ADDENDUM 1 (PENDING DSA APPROVAL)

PROJECT: **Santa Ana College**
 Science Center

DATE: 8/23/2017

DSA File No.: 30-C2
DSA Applications No.: 04-115788
HGA Commission No.: 3584-001-00

3 EXTERIOR DETAIL AT CANOPY ALTERNATE #1
 1 1/2" = 1'-0"

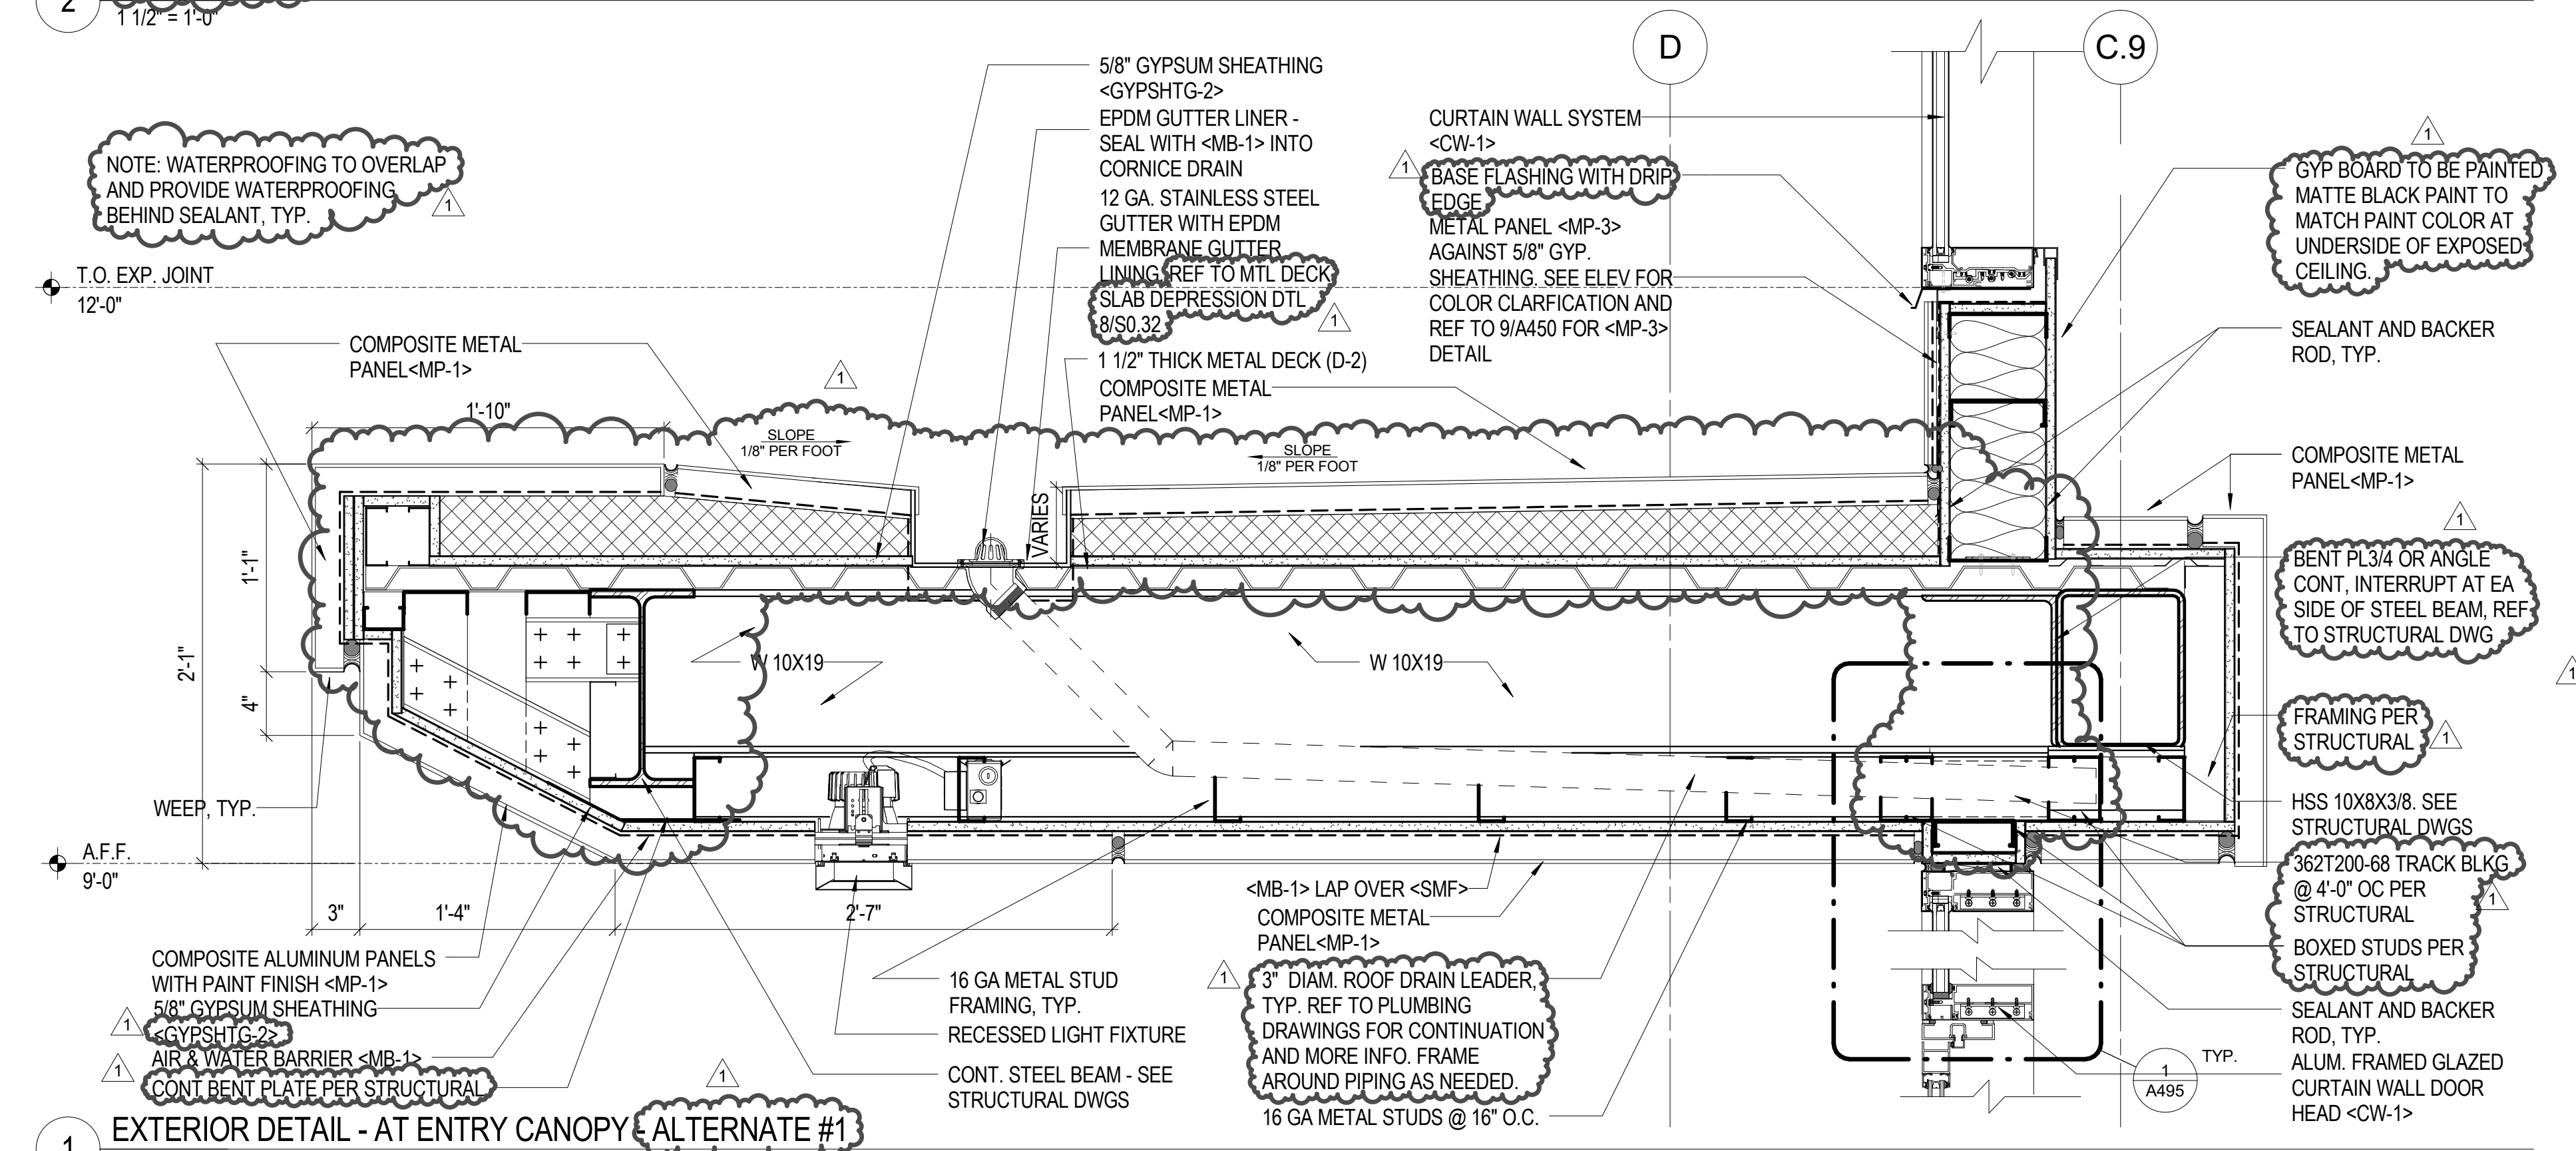
- North canopy reduced by 5'-0" at Details 1, 2, and 3.
- Framing at canopy revised to match structural drawings at Details 1, 2, and 3.
- Added detail 4, Enlarged Canopy Roof Plan- Alternate #1

A451

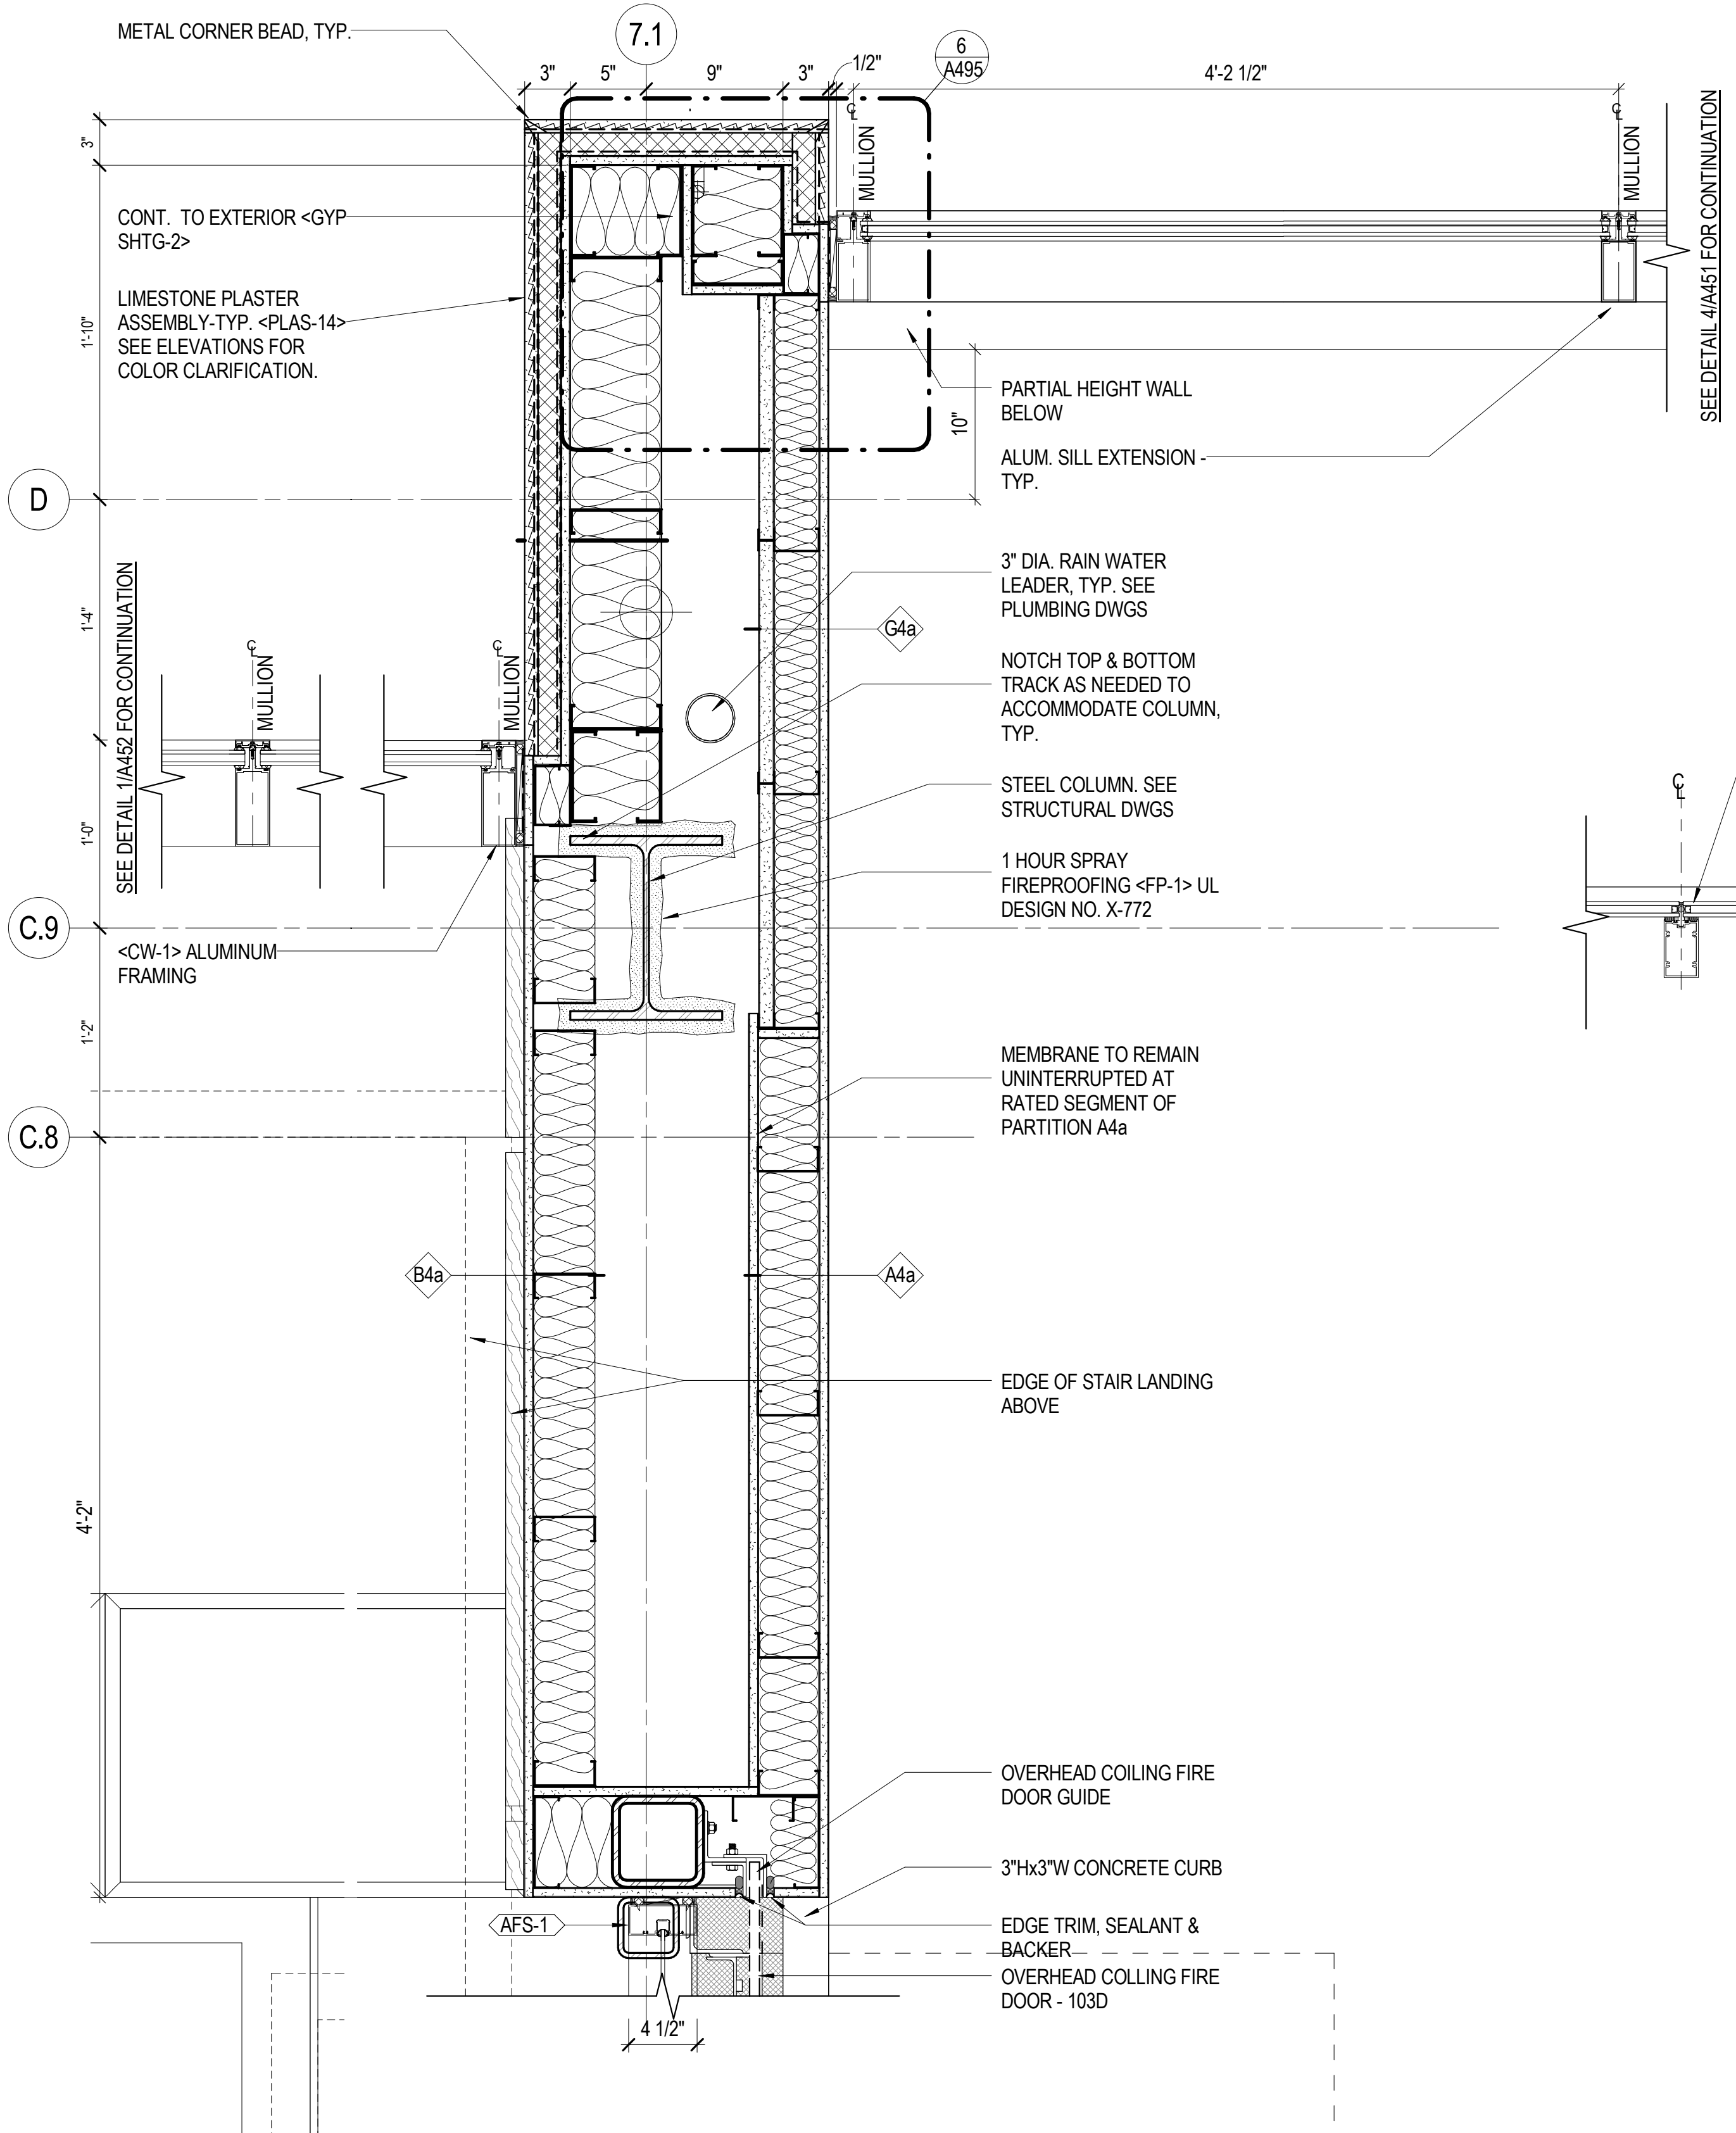
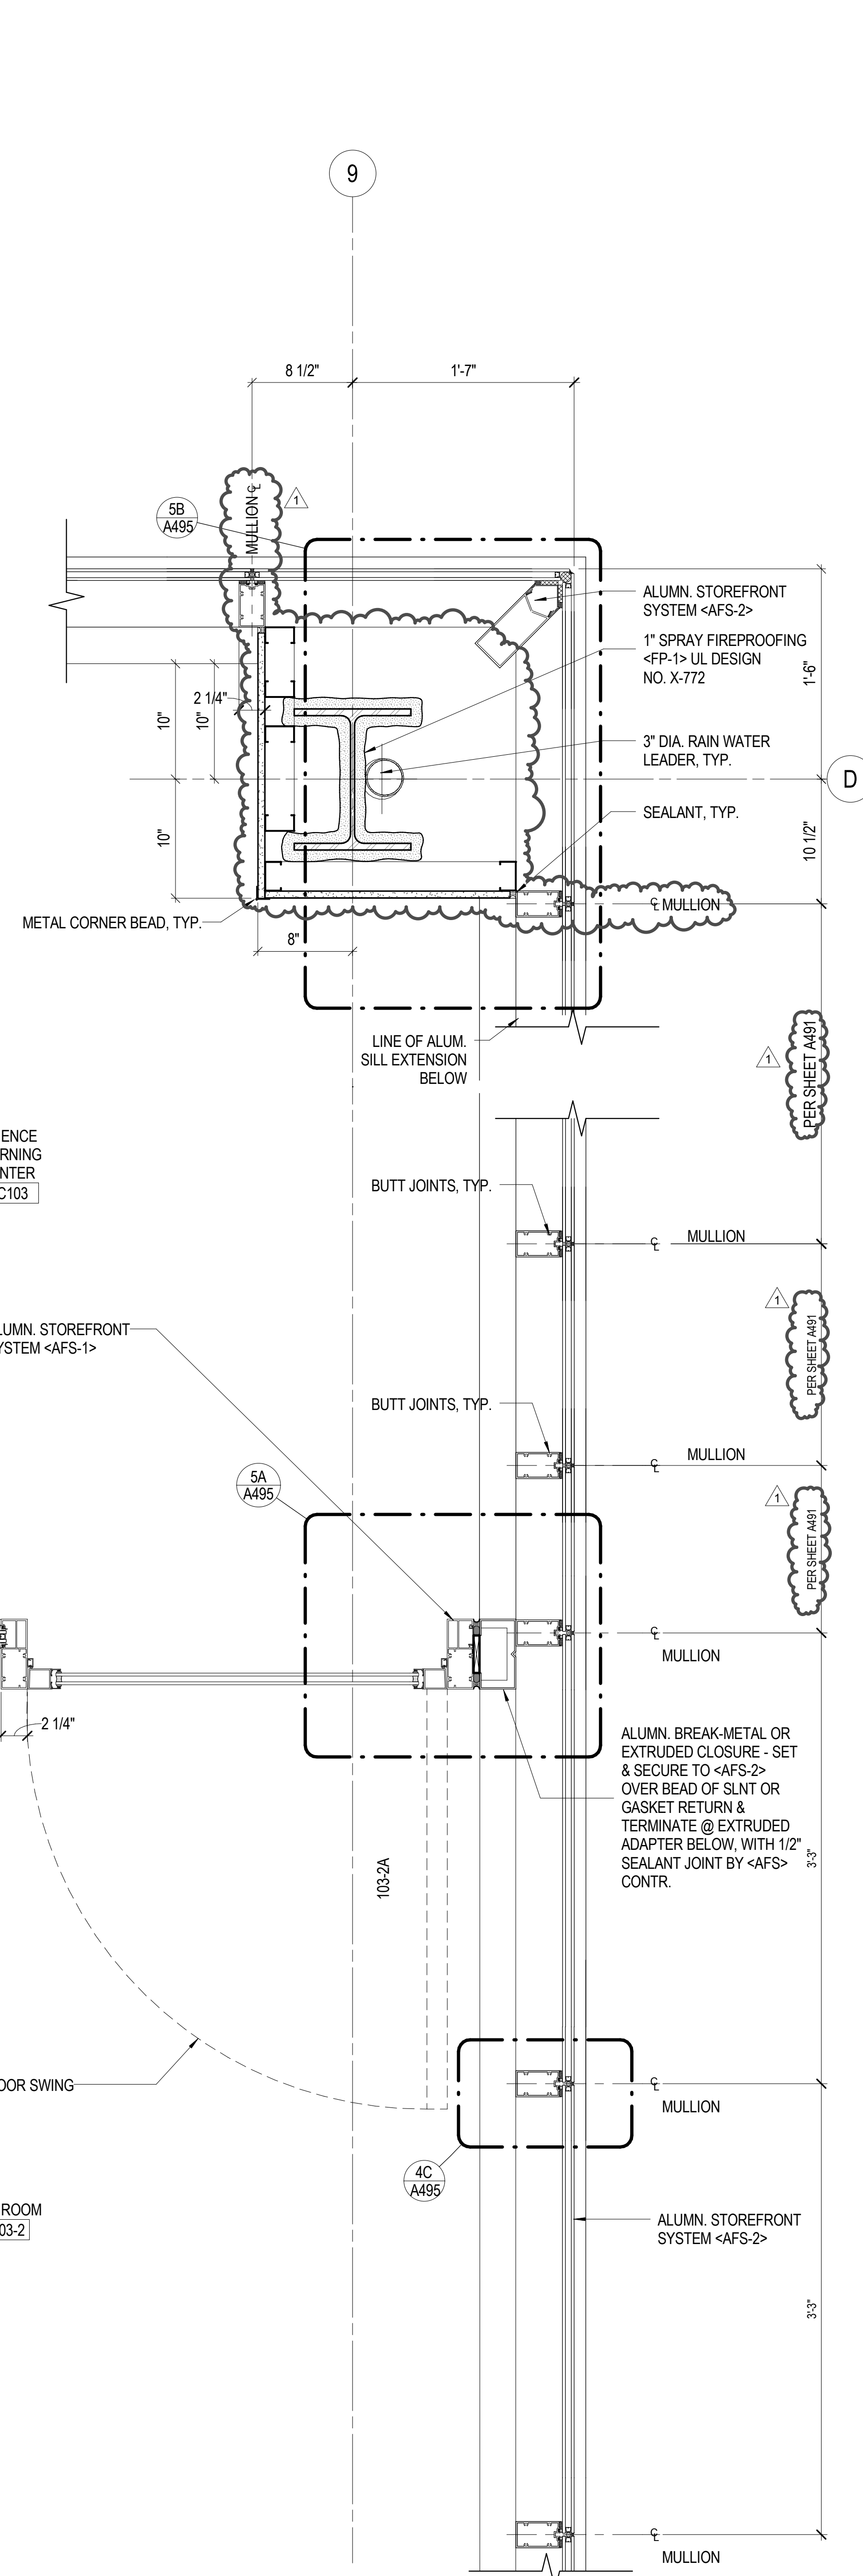
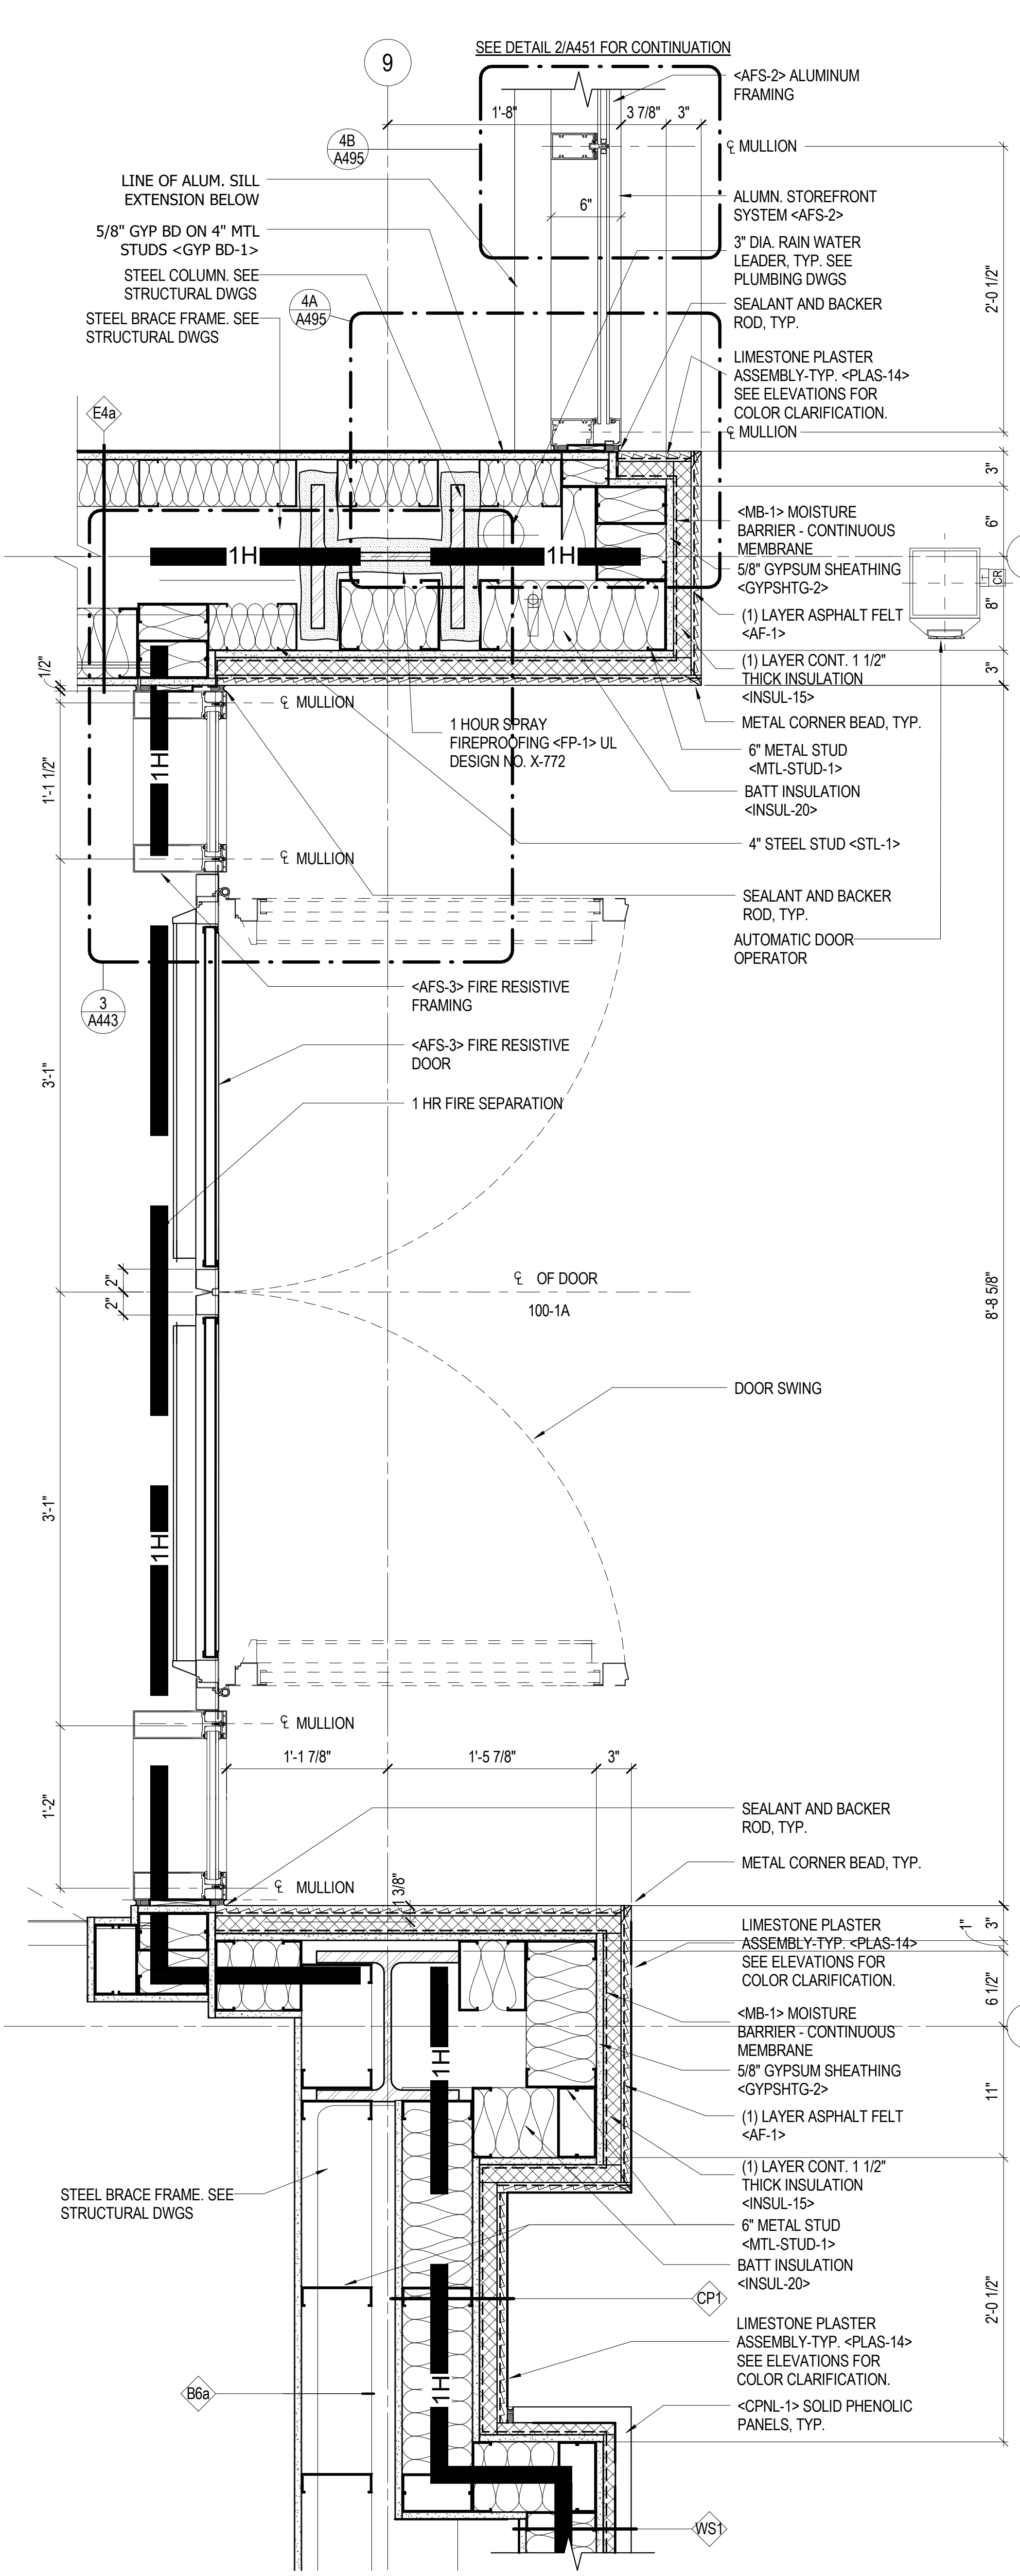
- Columns furrowed out to edge of storefront at Detail 2 and 4.
- Butt joint locations updated at Detail 2 and 4.
